Technical Service Bulletin: TSB170079

Released Date: 30-Apr-2018

Incorrect Aftertreatment Part Number Etching

Figure 2, Aftertreatment DOC E PN and C PN Location.

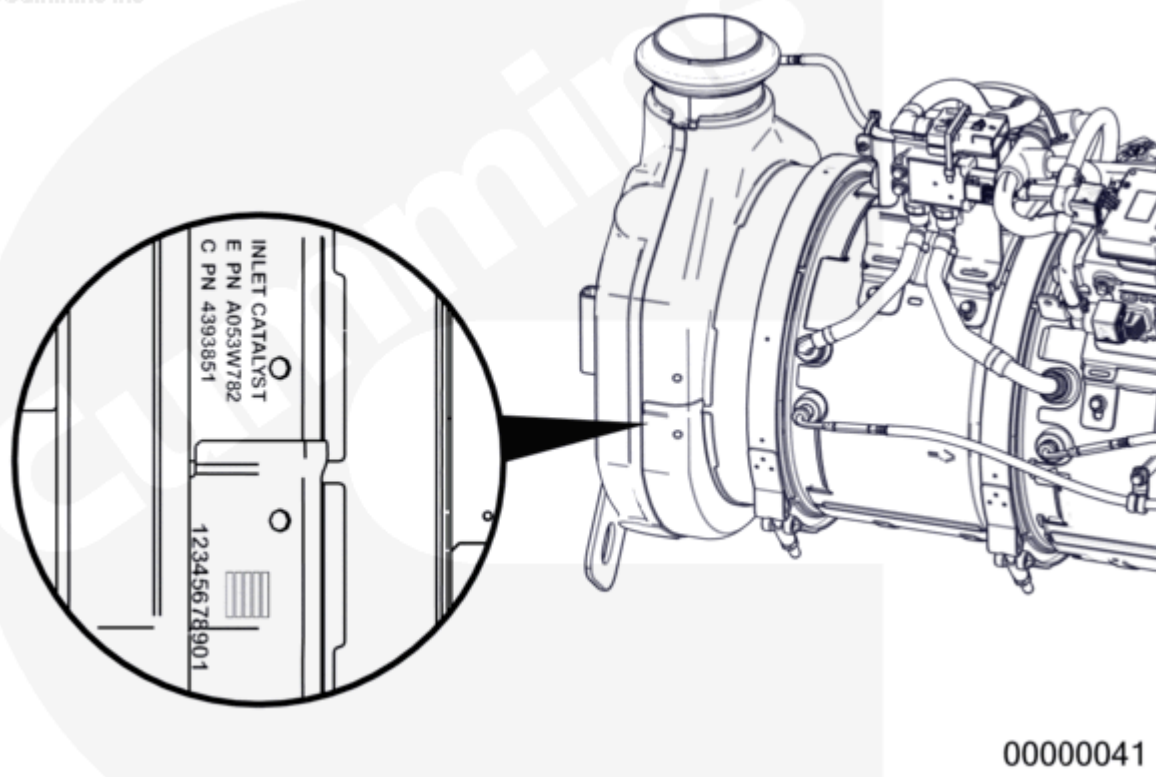
- Figure 1 below displays location of entire assembly part number, which can guide in further identification of needed individual parts.
- Figure 2 below displays location of E PN and C PN on aftertreatment DOC.
